H087NAS1

TECHNICAL BULLETIN

501-02: Front End Body Panels

Service Action: Hood Seal Freezing

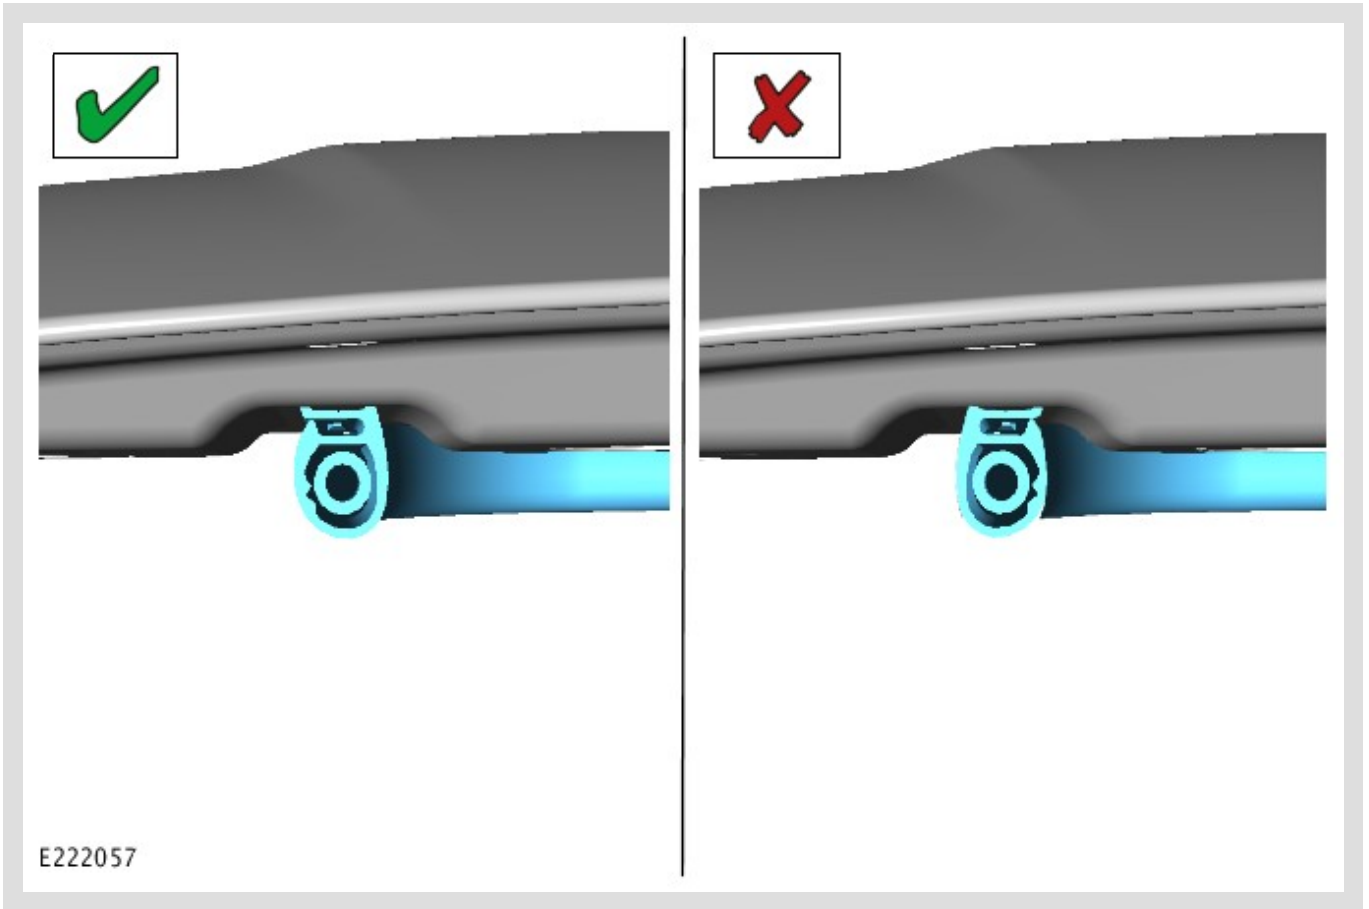
An issue has been identified on certain vehicles within the listed Affected Vehicle Range where the hood seal absorbs water and freezes to the lock panel. When the hood is opened, the seal can get damaged, unclipped, or lost.

Remove and discard the hood seal.

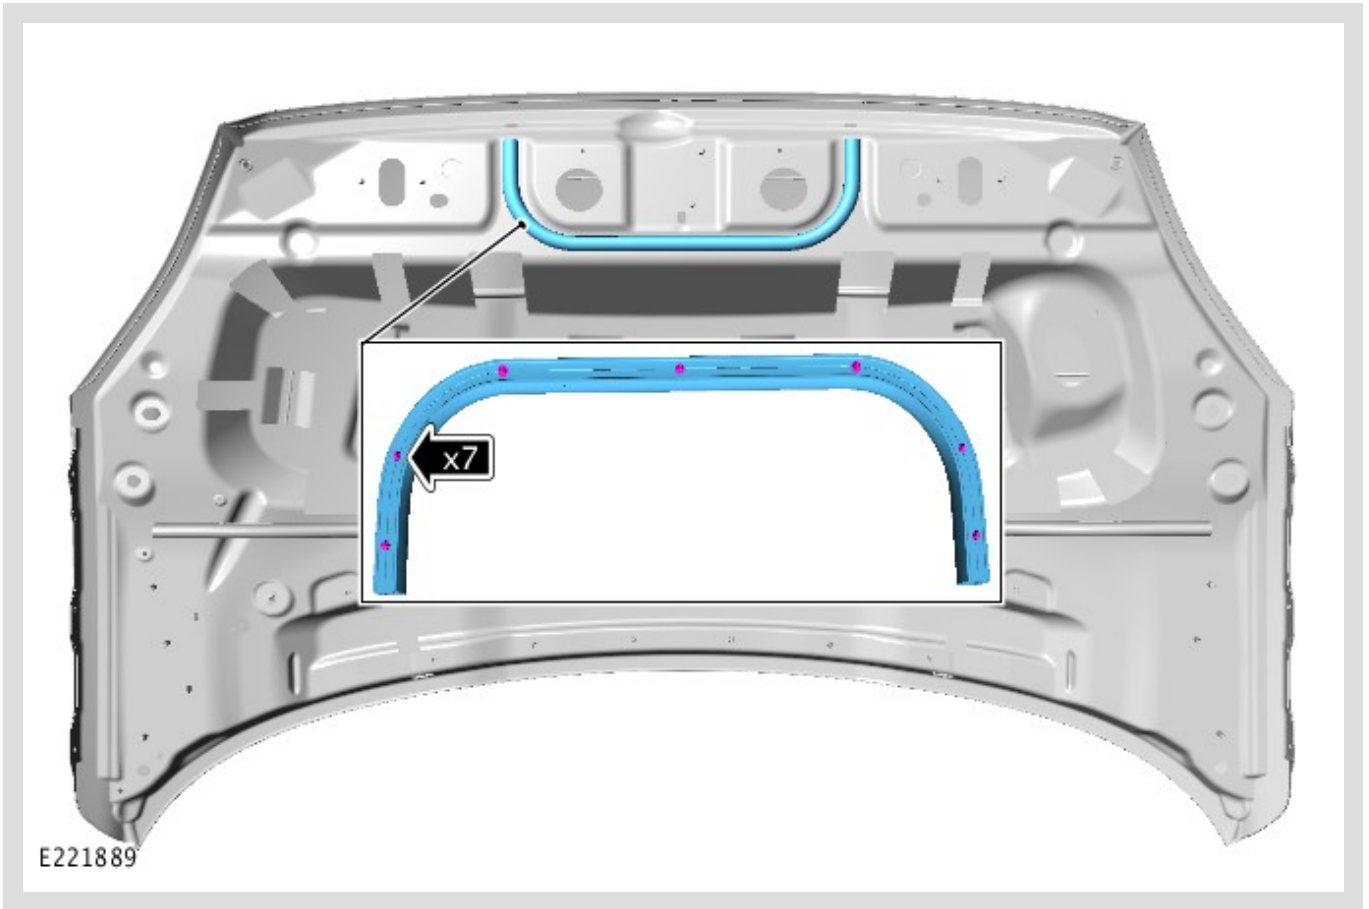
Note the correct (✓) orientation of the new seal.

Install the new hood seal.
